To: T10 Technical Committee
From: Robert Sheffield (Robert.L.Sheffield@intel.com), Intel Corporation
Date: May 12, 2004
Subject: T10/04-030r2, SAS-1.1: Fix SP Hang States

Overview

Figure 68 — SP (phy layer) state machine - OOB sequence states

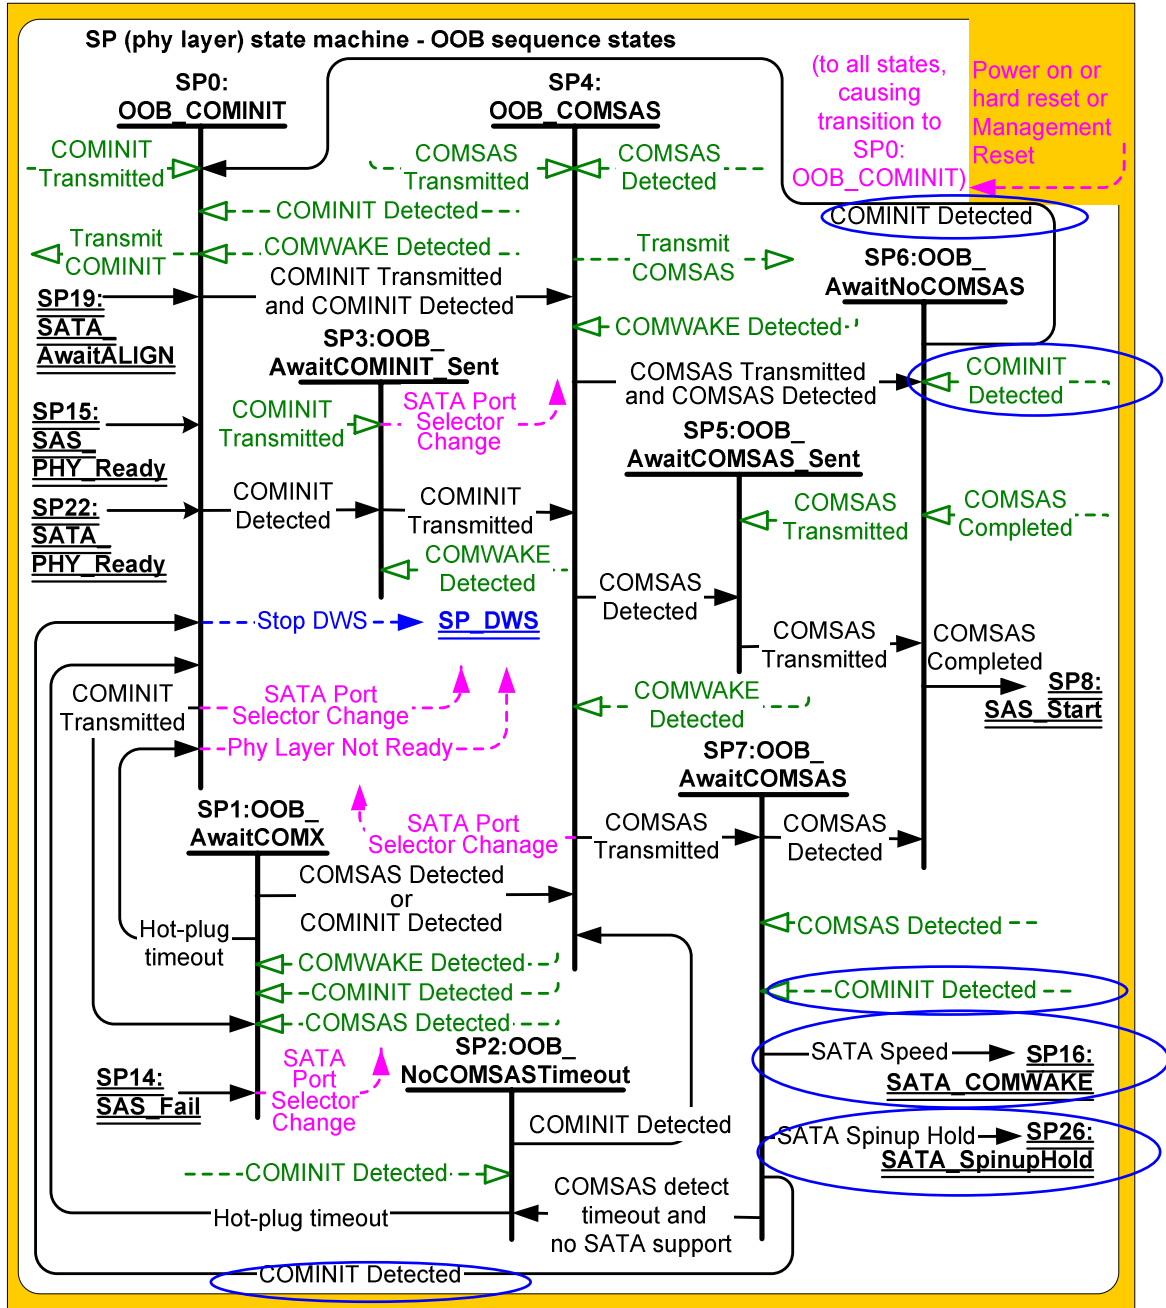
Replace figure 61 in section 6.7.3.1 OOB sequence states overview with the following figure:

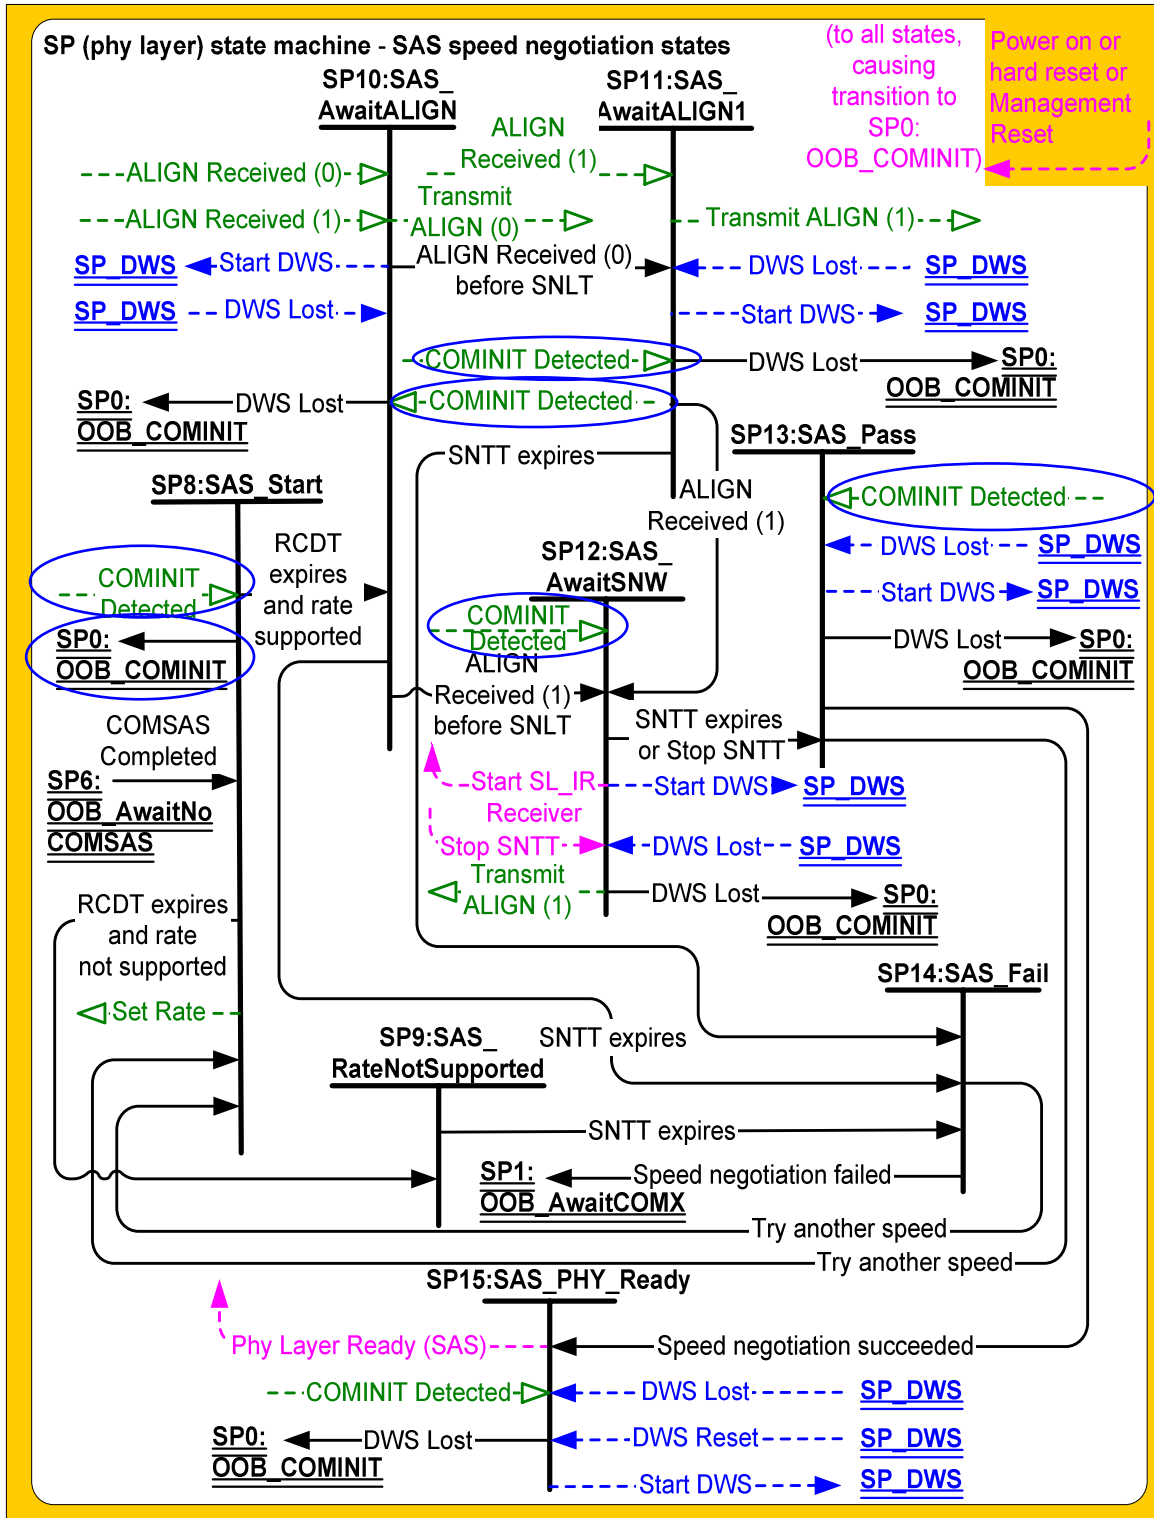
Replace figure 69 – SP (phy layer) state machine – speed negotiation states with the following figure:

Add subclause 6.7.4.2.4 describing the new transition to SP0 as follows:

6.7.4.2.4 Transition SP8:SAS_Start to SP0:OOB_COMINIT

This transition shall occur after receiving a COMINIT Detected message.

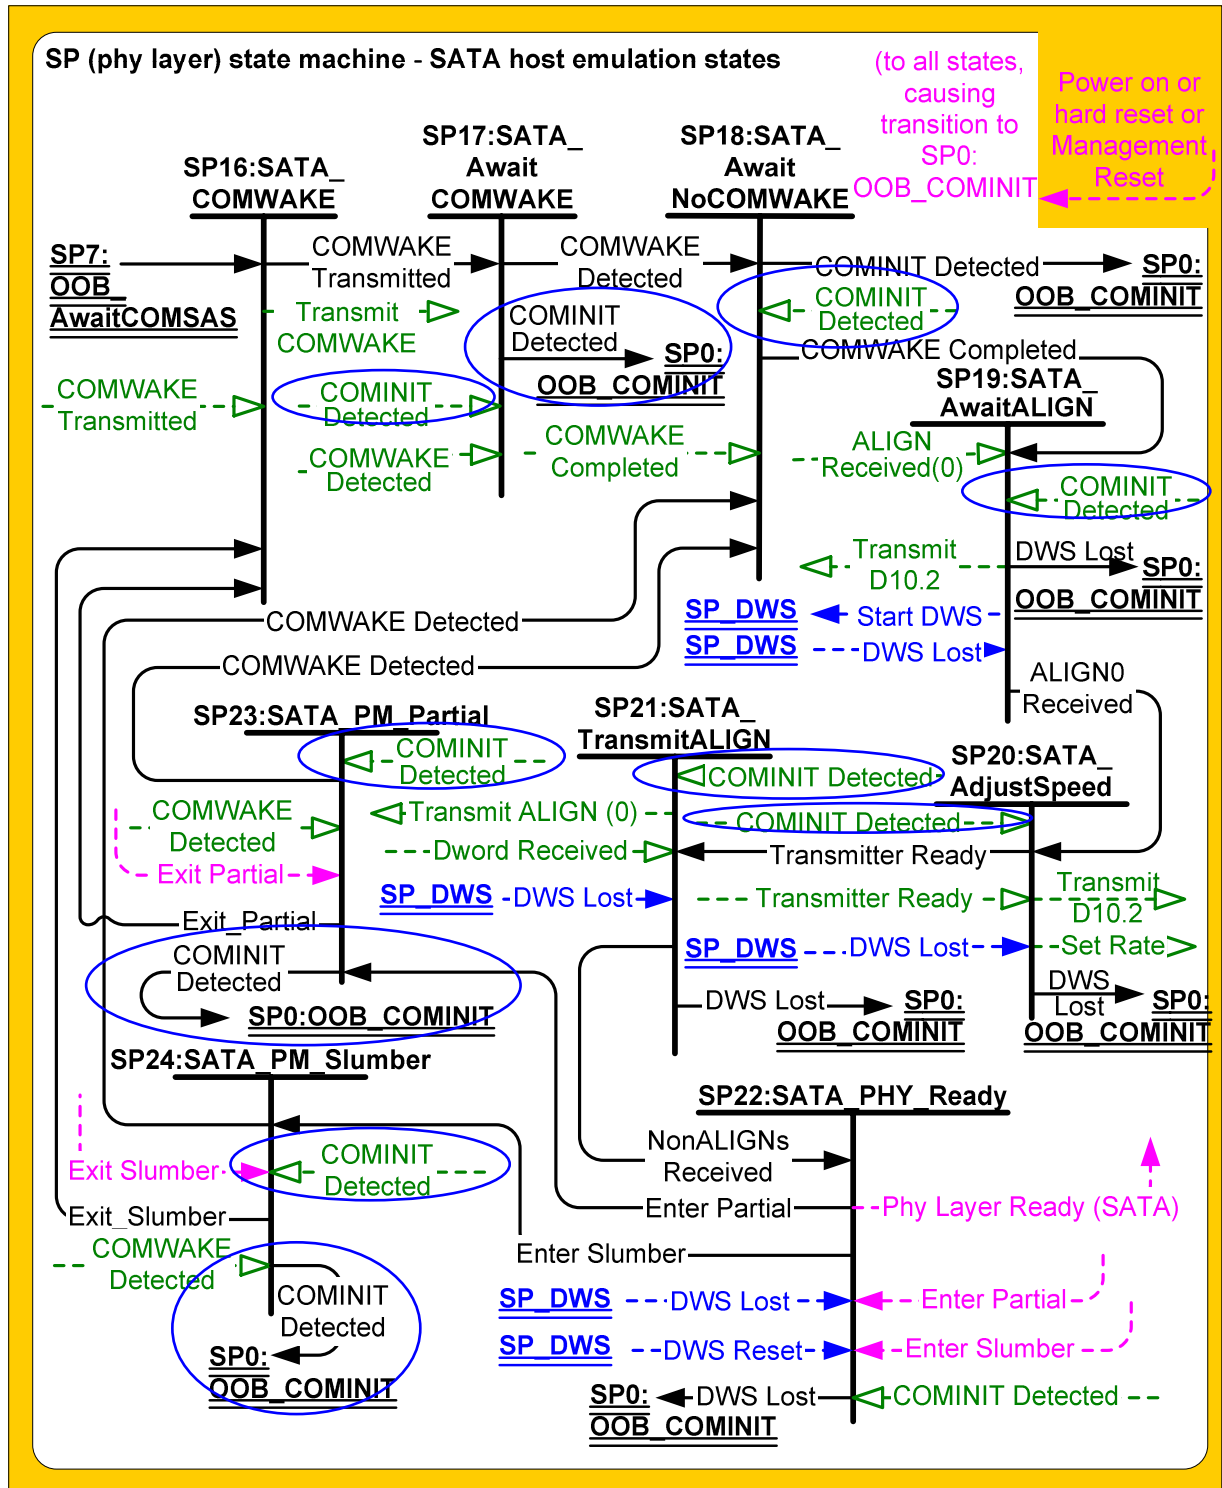
Replace figure 70 – SP (phy layer) state machine – SATA emulation states with the following figure:

Add subclause 6.7.5.3.3 describing the new transition to SP0 as follows:

6.7.5.3.3 Transition SP17:SATA_AwaitCOMWAKE to SP0:OOB_COMINIT

This transition shall occur after receiving a COMINIT Detected message.

Figure 72 — SP (phy layer) state machine – SATA Spinup Hold State

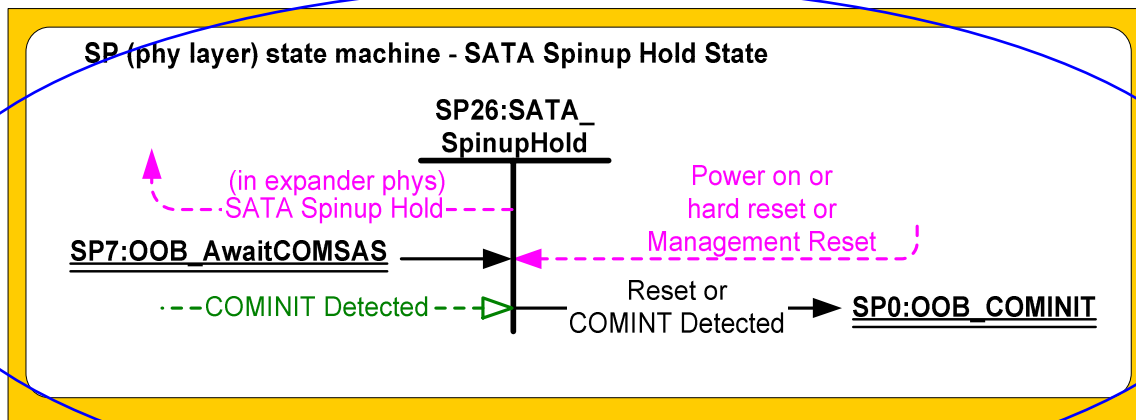
Figure 72 shows the SP26:SATA_SpinupHold state. This state shall be entered from the SP7:OOB_AwaitCOMSAS state upon detection of a COMSAS detect timeout if the phy supports SATA, the phy supports Spinup Hold, and the MgmtReset state machine variable has a value of zero.

6.7.7.2 Transition SP26:SATA_SpinupHold to SP0:OOB_COMINIT

This transition shall occur if this state receives a COMINIT Detected message, a Management Reset request from the management layer, a hard reset, or a power on. If this transition is caused by a Management Reset Request from the management layer, it shall cause MgmtReset to be set to one upon entry to SP0:OOB_COMINIT. Otherwise, MgmtReset shall be set to zero upon entry to SP0:OOB_COMINIT.
